AGENDA
PARKS, RECREATION & NATURAL RESOURCES COMMITTEE
MEETING

To: Kris Jenson, Planning Manager

Progressive, LLC is proposing development of 51 dwelling units on 21.3 acres of land located at the southwest corner of Kenwood Avenue (CSAH 50) and Ipava Avenue. The proposed development requires consideration of applications for a Comprehensive Plan amendment guiding the property for a single residential land use category; Zoning Map rezoning portions of the property to RST-2 District; a Conditional Use Permit for Planned Shoreland Development; Preliminary Plat; and Vacation of existing public right-of-way.

PRELIMINARY SITE PLAN

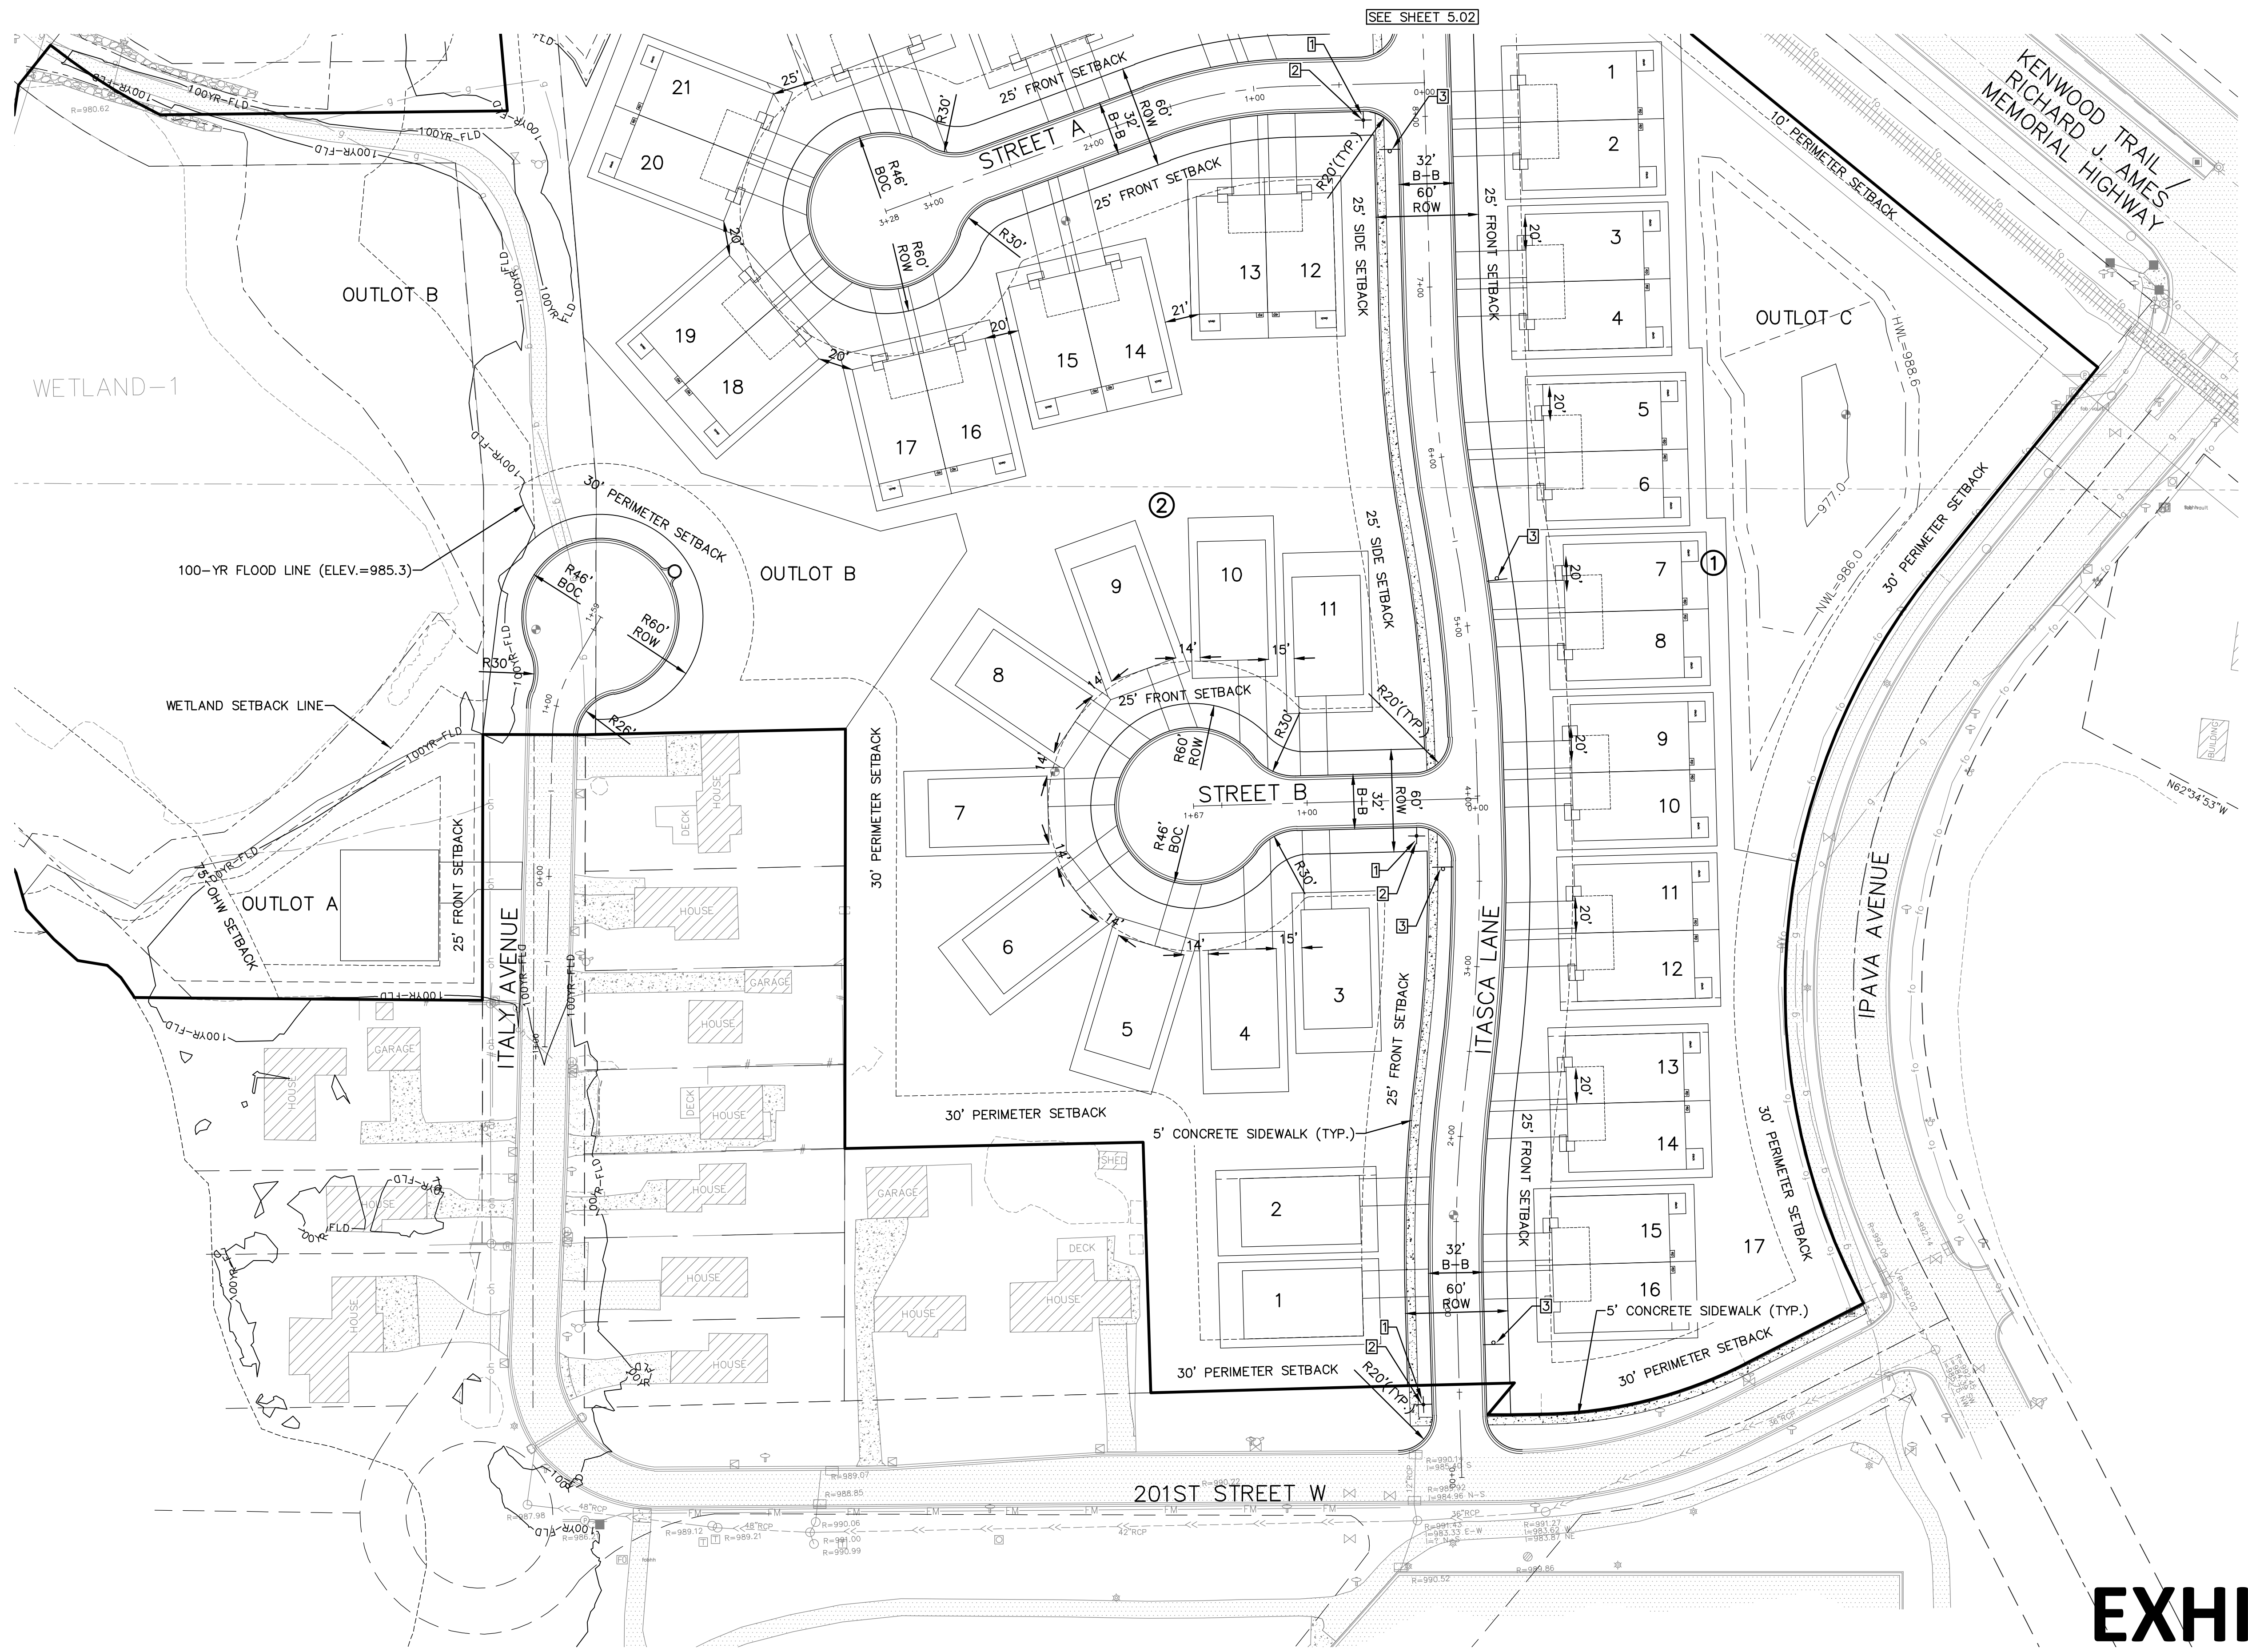
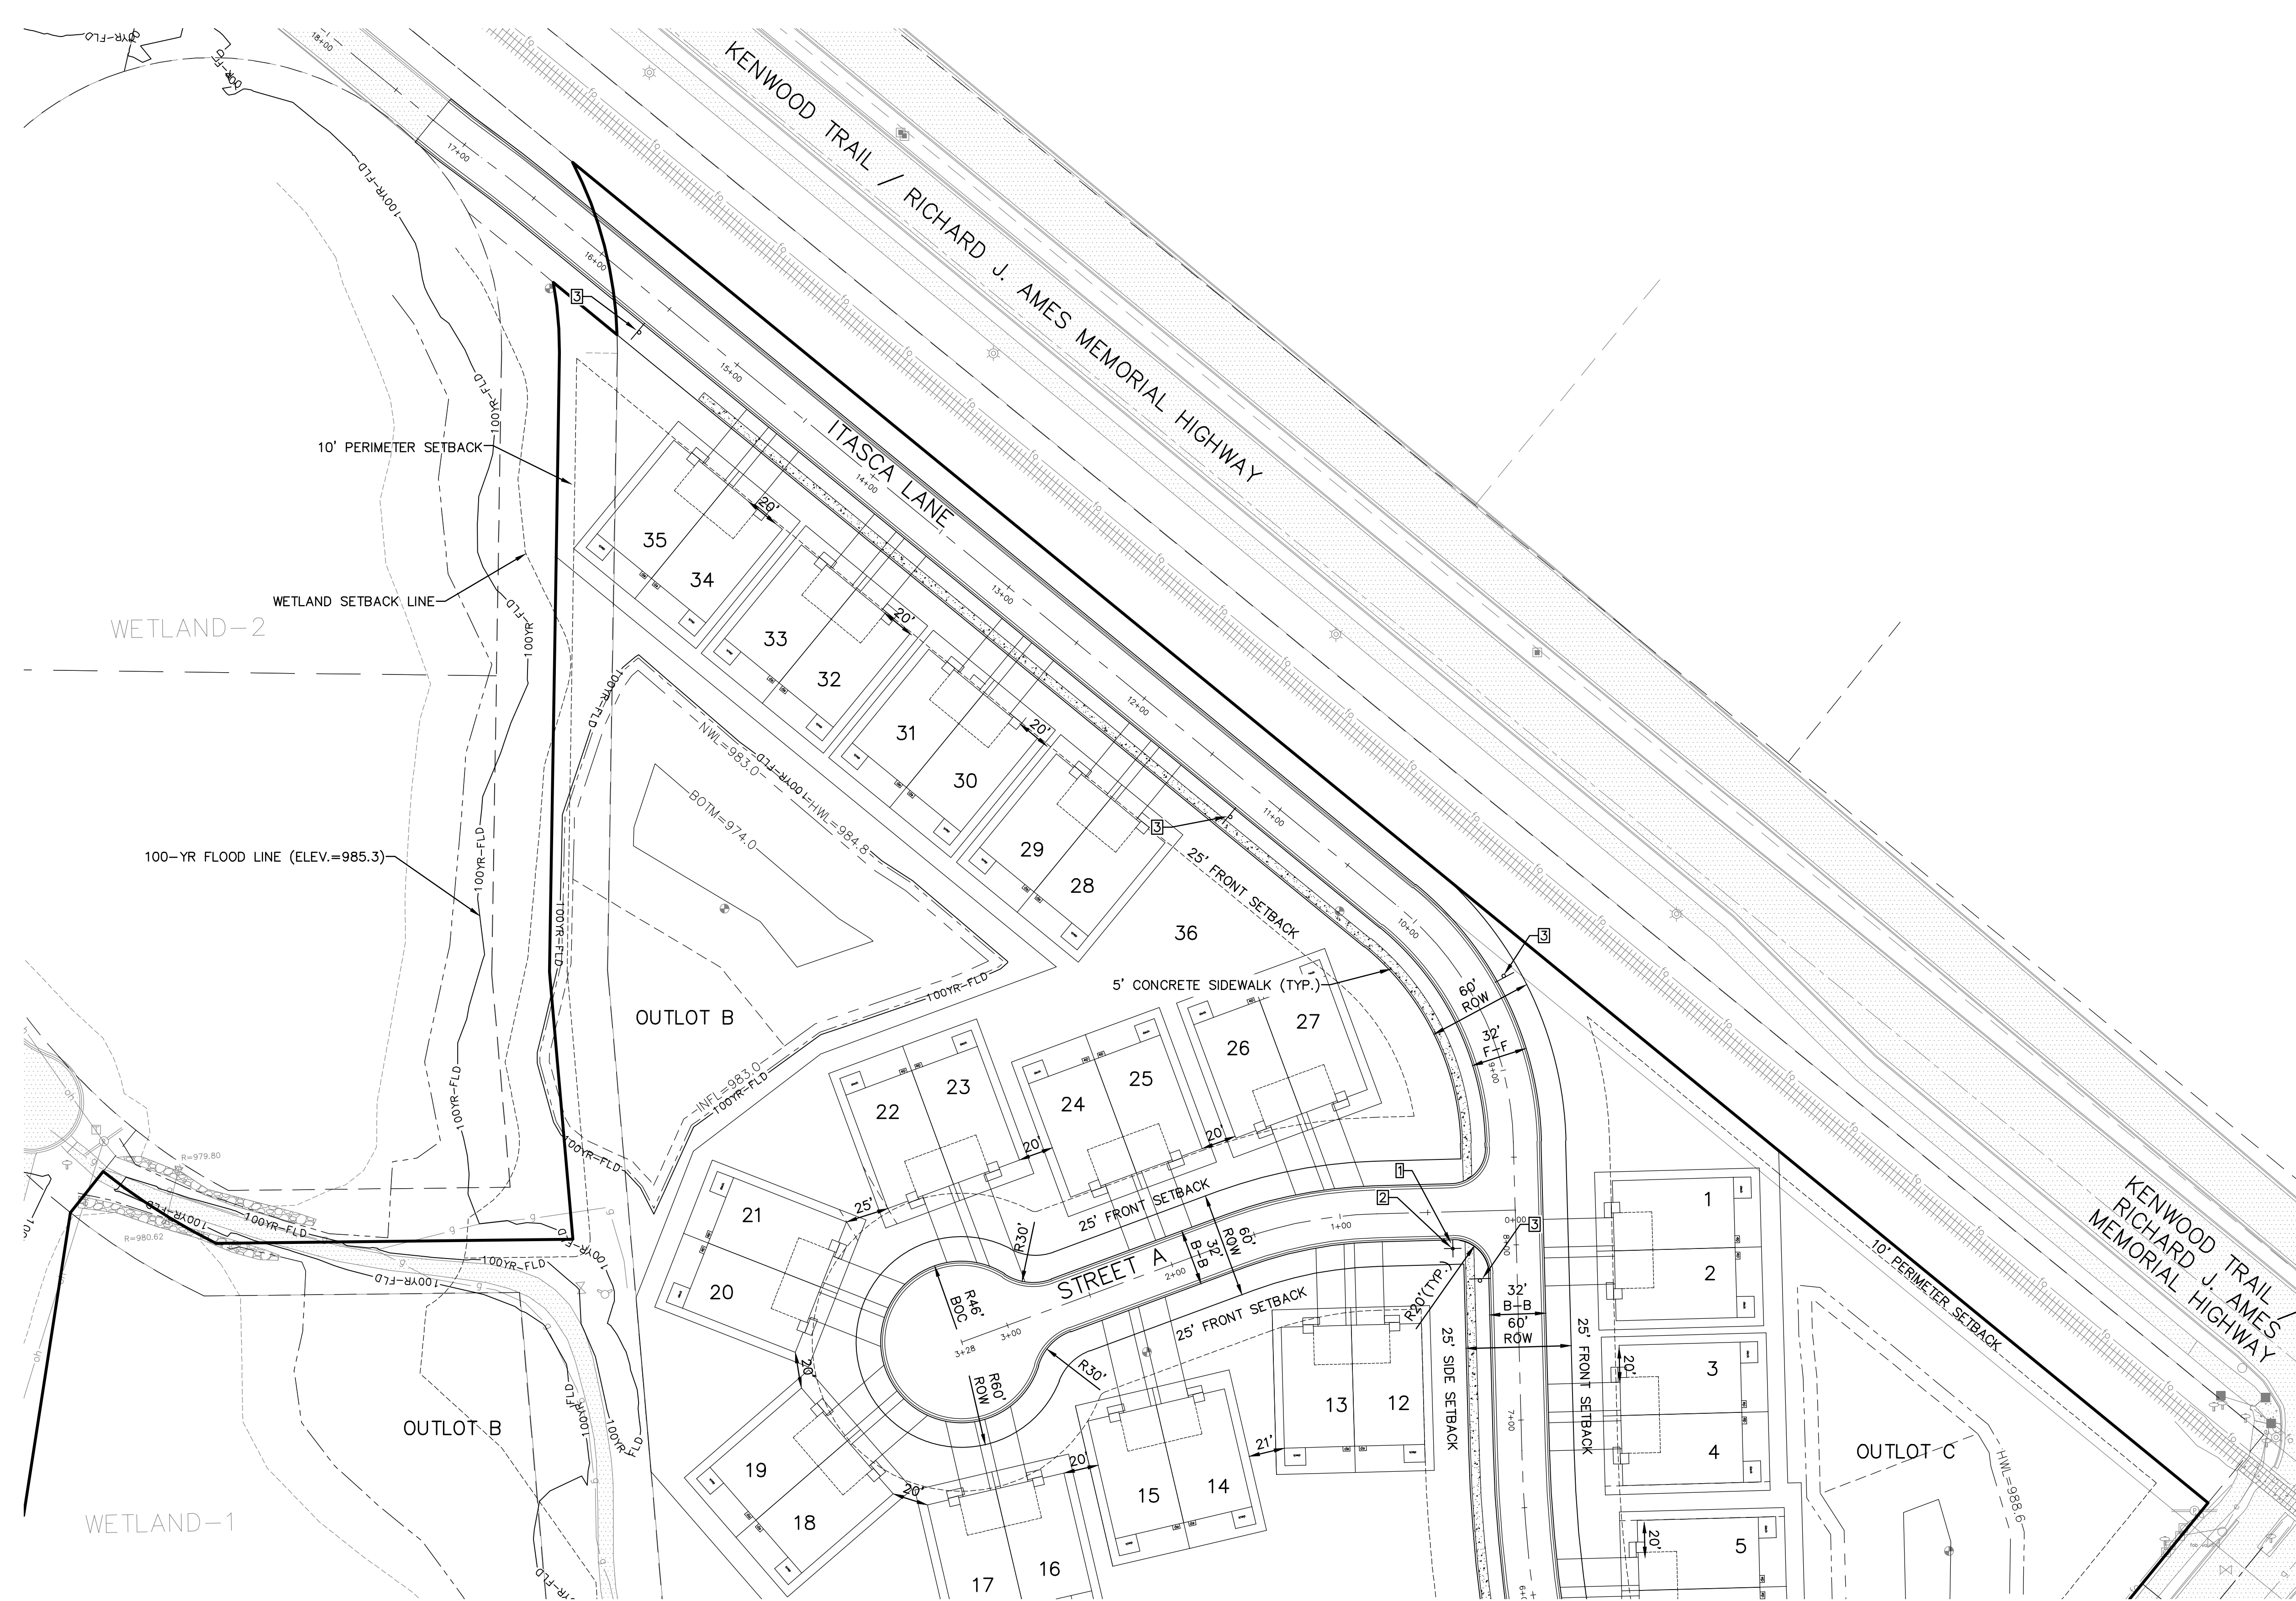
Setbacks. The table below summarizes the setbacks required for the dwelling units within Blocks 1 and 2 of the proposed preliminary plat. The setbacks shown on the preliminary site plan (Sheets 5.01 and 5.02) for the detached townhomes and twin homes comply with the RST-2 setback requirements.
